Re: Responses to Agency Review Comments and Request for Additional Information, Zeolite Mine Modification 20-1 Application, Permit No. SI006RE – Sierra County, New Mexico

Re: Responses to Agency Review Comments and Request for Additional Information, Zeolite Mine Modification 20-1 Application, Permit No. SI006RE – Sierra County, New Mexico

**Sediment Ponds Design and Calculations**

ST. CLOUD MINING COMPANY  
T12S, R8W, SEC. 4  
SIERRA COUNTY  
NEW MEXICO

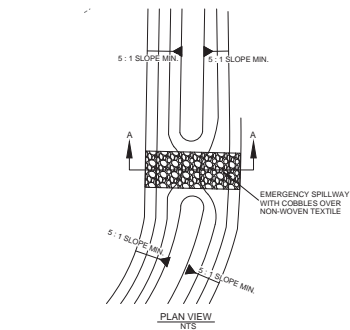
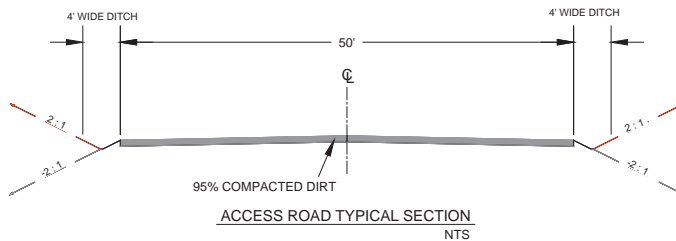
8. ***Attachment 7 page 2 has the total acreage for revegetation and monitoring as 43.5 acres but the total area to be regraded is 37 acres. What disturbed areas are included in the 6.5 acre difference?***

Response: St. Cloud has reassessed the total acreage since the sediment ponds calculations and design has been completed. Sediment ponds 1 and 2 have been relocated from where they were shown in St.

Cloud's original submittal and their new location requires the construction of "swales" to direct water into the ponds. The design of the swales is shown on Drawing 6 of 7 of the Pond Design Documents (Attachment P) prepared by Thompson Engineering. St. Cloud has included these swales in the updated calculations of the Reclamation Cost Estimate (Attachment R). The swales will be reseeded at time of construction, and are expected to be well established, self-sustaining ecosystems at time of project completion. The swales are shown on Drawing 3 of 7 in the Pond Design Documents (Attachment P). St. Cloud has used a standard width of 10 feet for all swales, although Drawing 6 of 7 states a maximum width of 8 feet. The length of the west swale is 1,816 lineal feet, and the length of the east swale is 2,716 lineal feet, totaling 4,532 lineal feet. 4,532 ft. length x 10 ft. width = 45,320 square feet or 1.04 acres. Since these swales will be revegetated at construction, they will not require regrading or any other reclamation treatments other than seeding and mulching. This amount of area to be reclaimed (1.04 acres) is include in the Reclamation Cost Estimate (Attachment R) on page 7, Revegetation Costs.
